1. To supplement Attachment B, please explain how SROG will monitor the pipeline between the Little Willow Facility and well DJS 2-14 to prevent leaks and/or spills.

2. *The application states on page 10 that a complete water flow testing and water analysis was done for two existing wells prior to developing the Willow Field. Data are presented for one of these two wells. To supplement Attachment E, provide the name, location, or value of Total Dissolved Solids for this other well.*

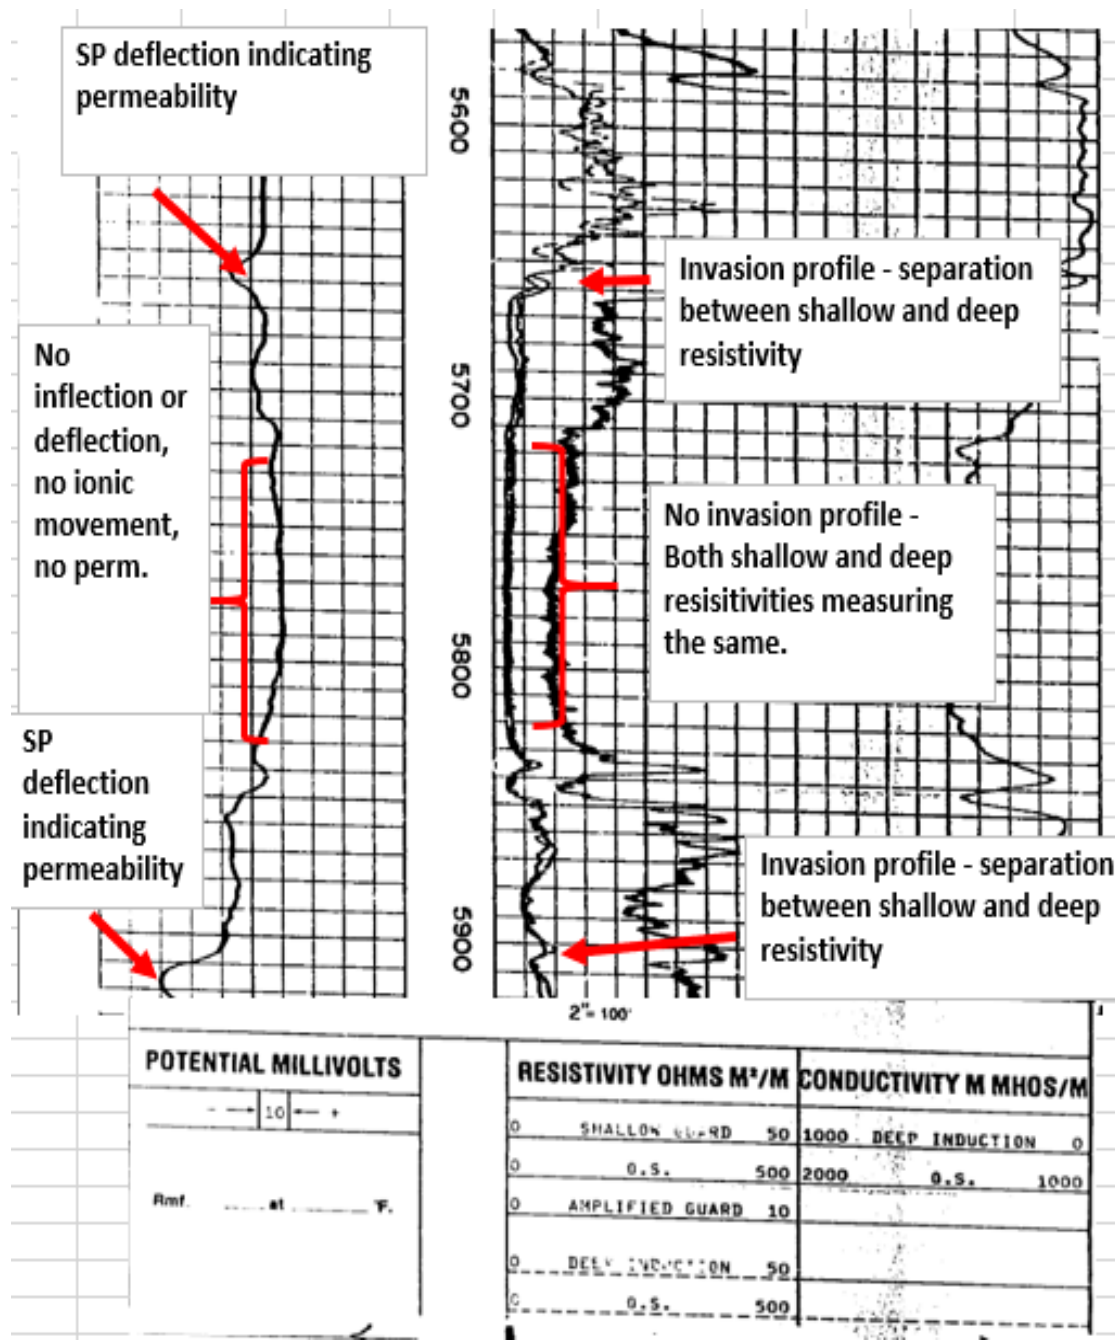
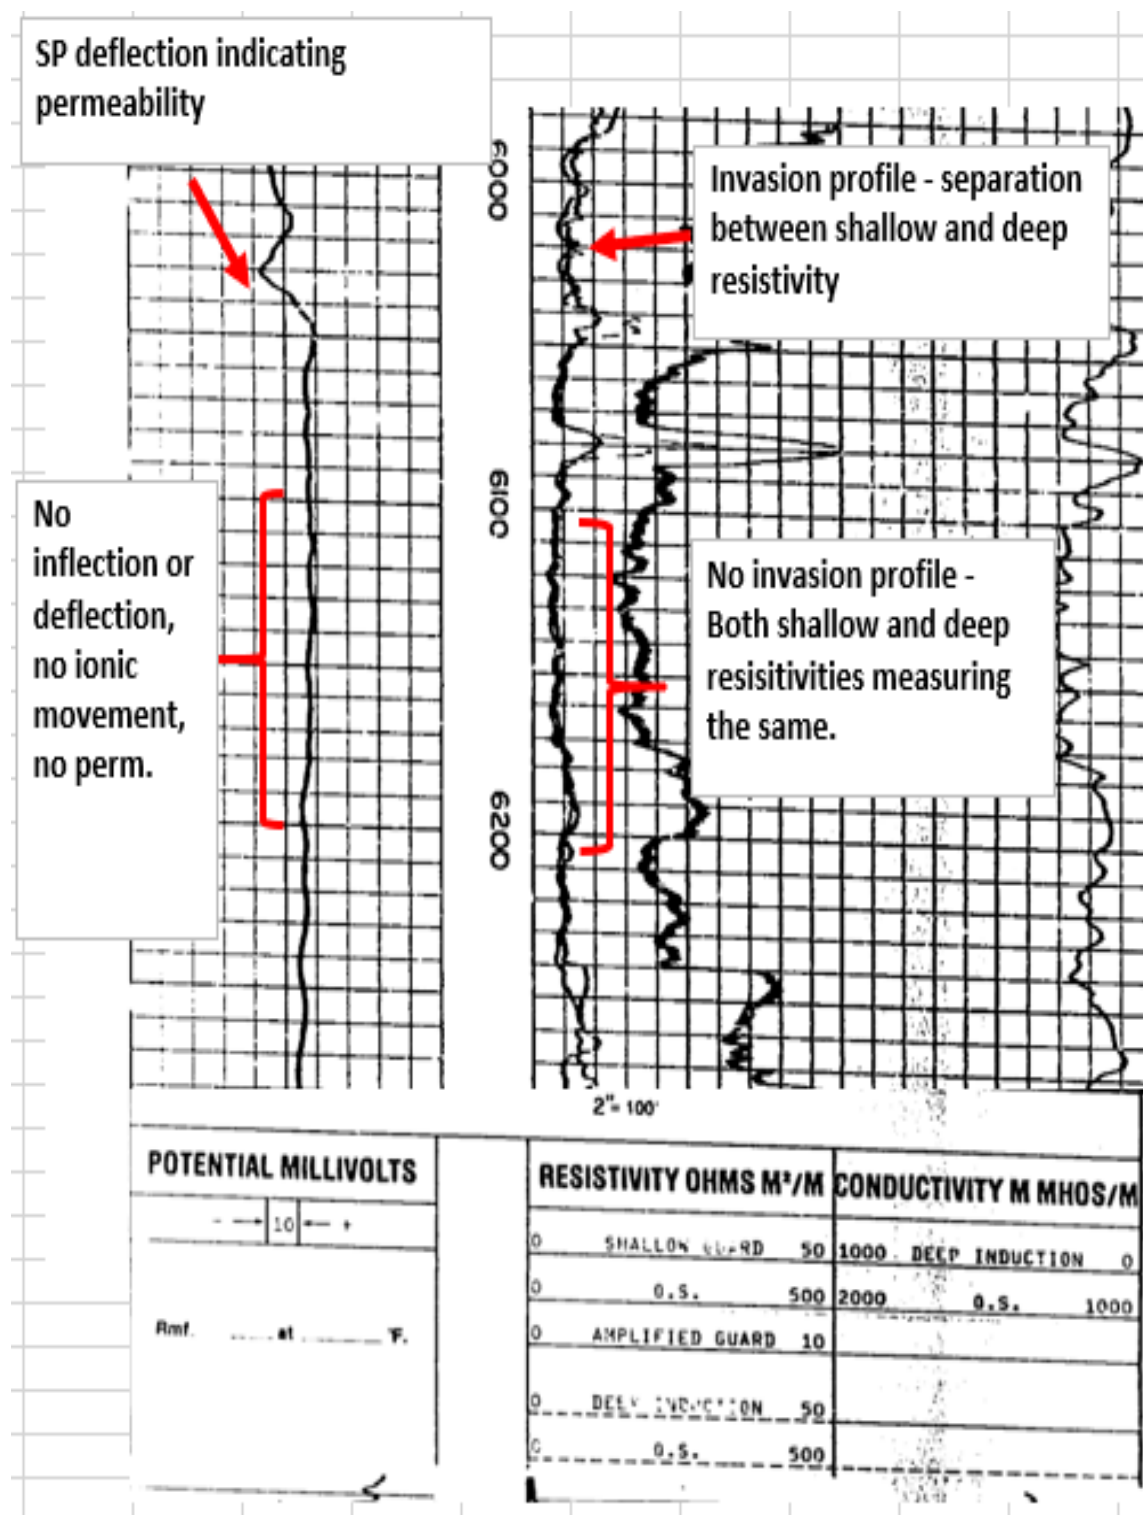
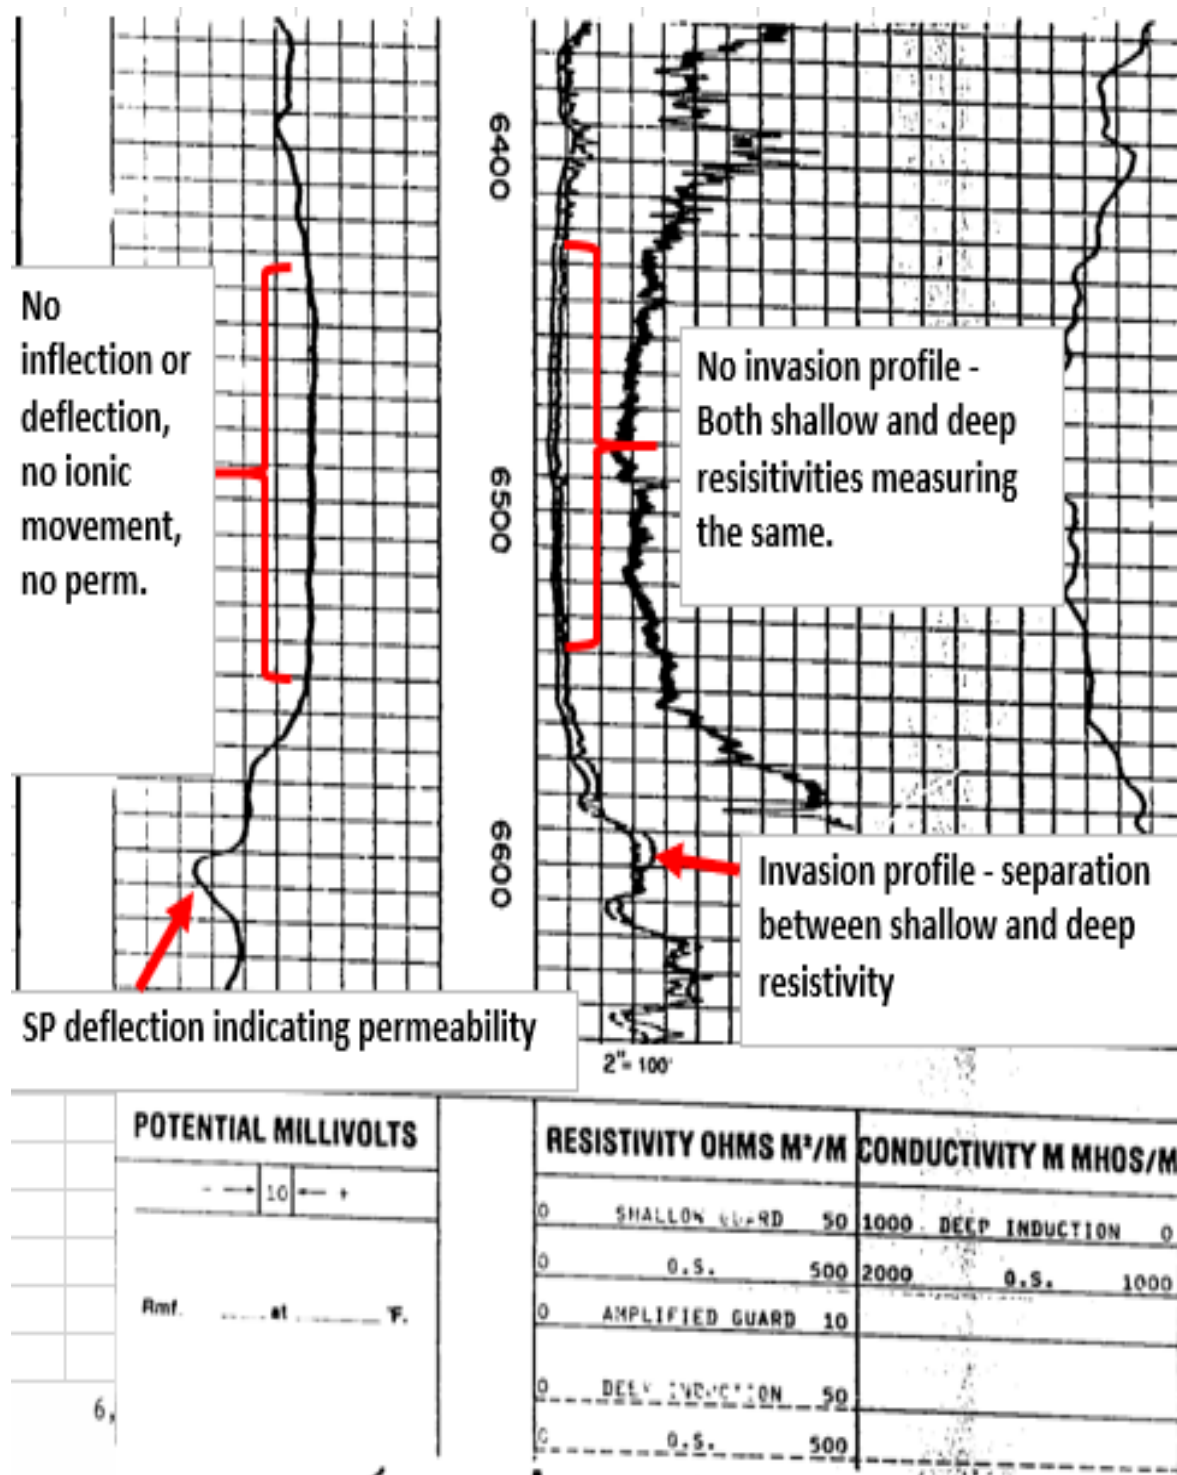
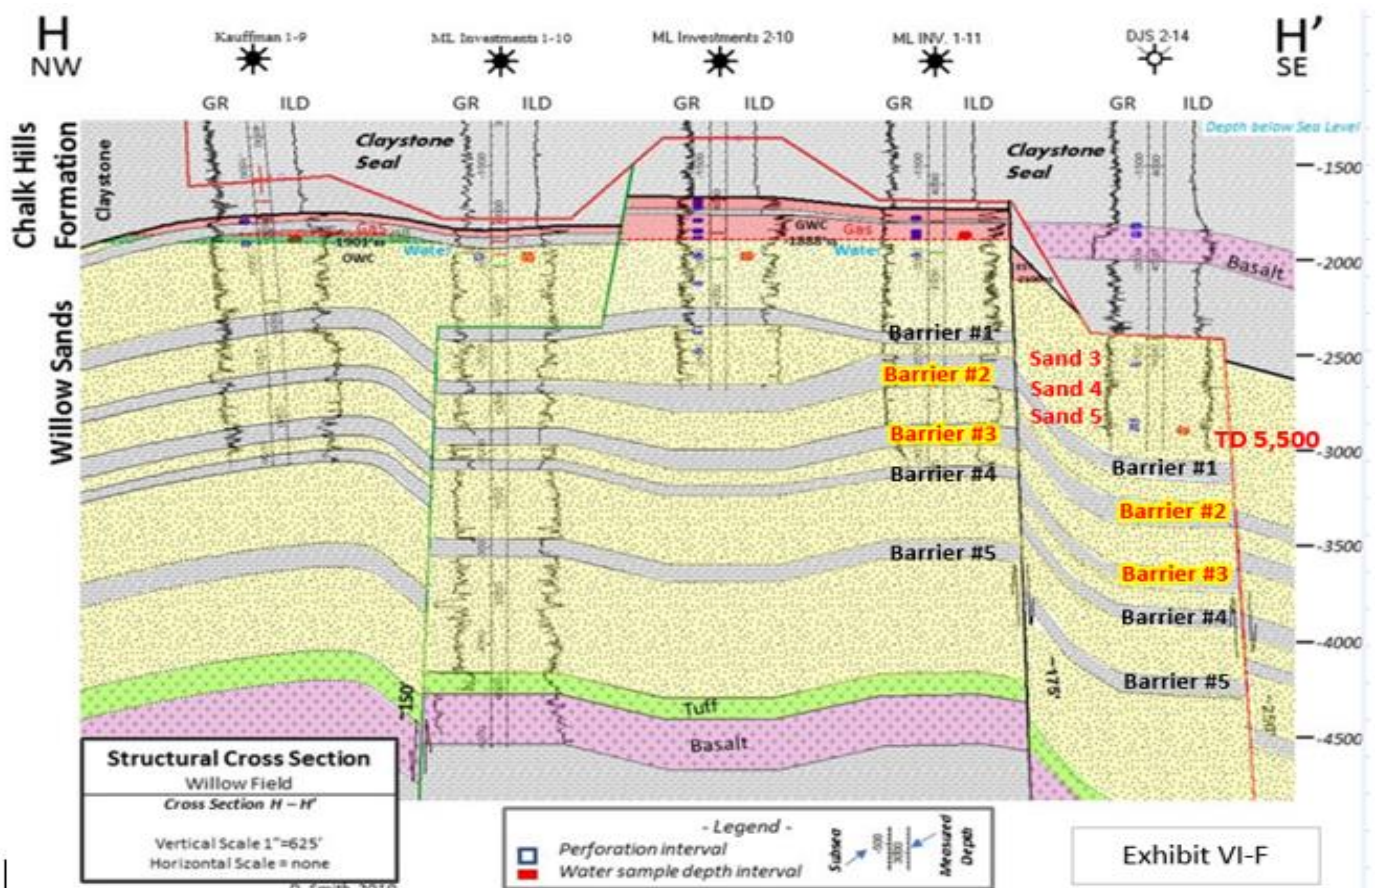
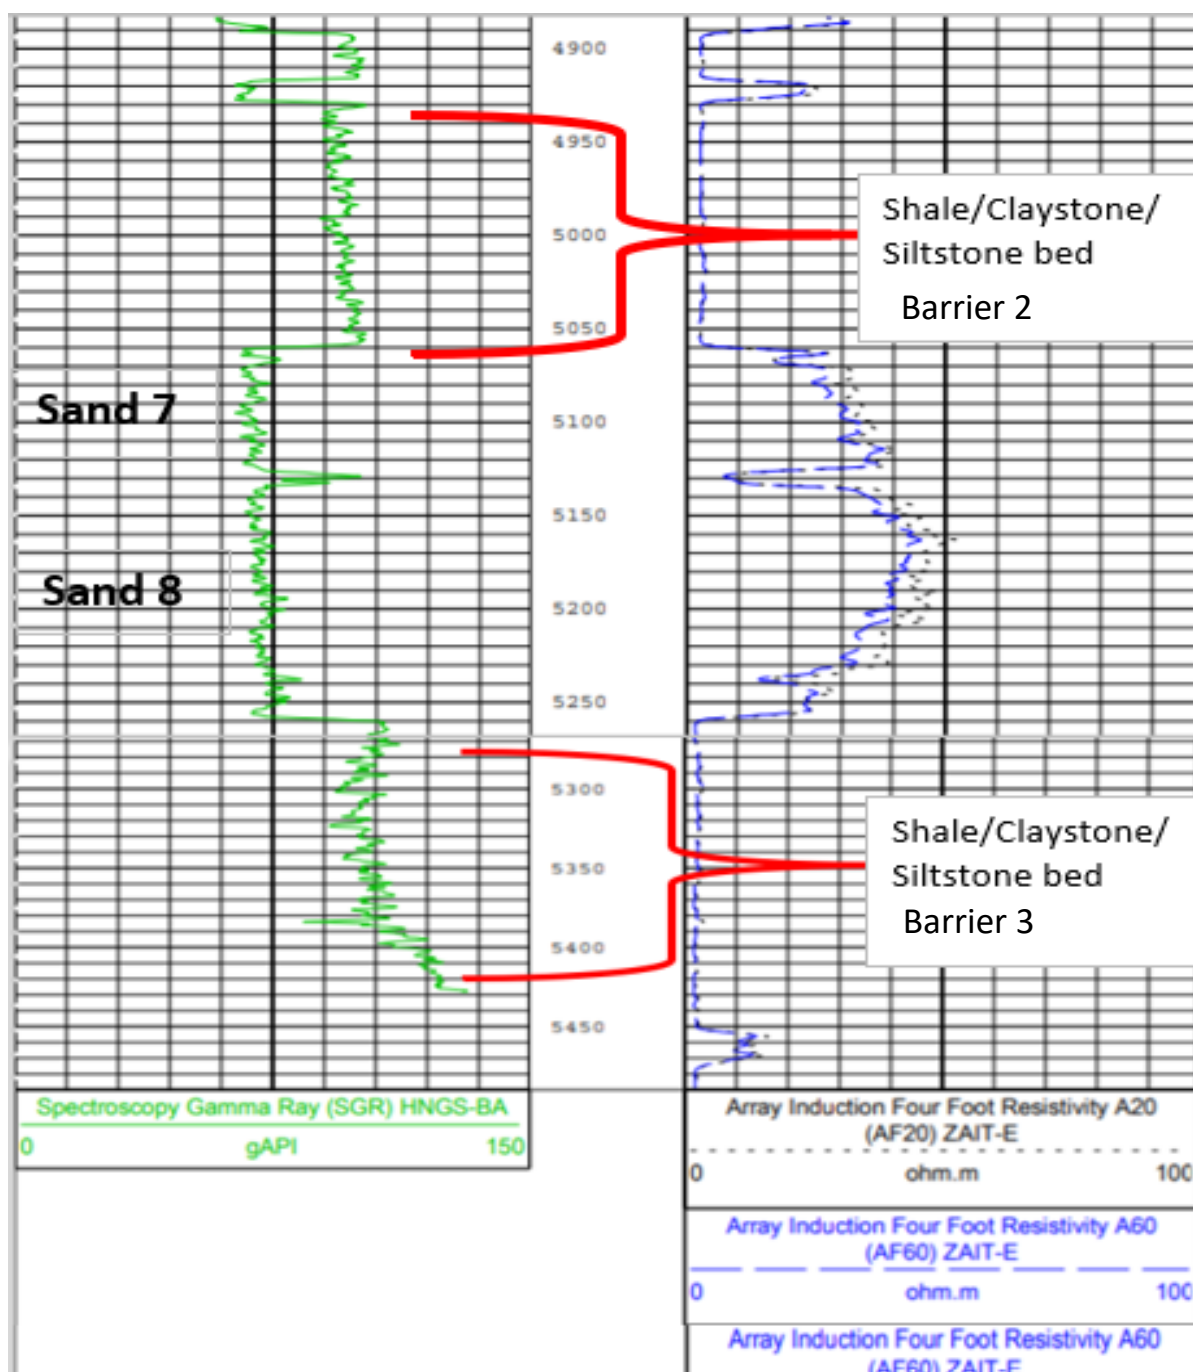
9. *To supplement Attachment G, provide evidence that the geologic intervals with volcanic character below the proposed injection zone will act as a competent lower confining interval. This may include estimates of permeability and porosity, comparisons with like-formations from other locations, or other available information.*

Similar to the upper competent seals mentioned in attachment G, the confining interval below the proposed injection zone exhibits excellent sealing characteristics as well. This argument is best supported by reviewing the well history and log data from a well drilled in 1979 by Ore-Ida Food Incorporated. This well was spudded on 8/19/79 and is located 8.6 miles west of the DJS 2-14 (see Fig 10-1). The section from 5,500' and below, is stratigraphically equivalent to the section immediately below the Willow sands in the DJS 2-14.

In addition to the unsuccessful flow test data, log data indicates the presence of a series of thick impermeable beds between 5,500' – 10,000' that exhibit a rock quality with low – zero permeability. These sections show log responses that are typical for low-zero perm rock. Evaluating the SP and resistivity curves across these log sections provide the differentiation between permeable and impermeable beds between 5,550' – 10,000'.
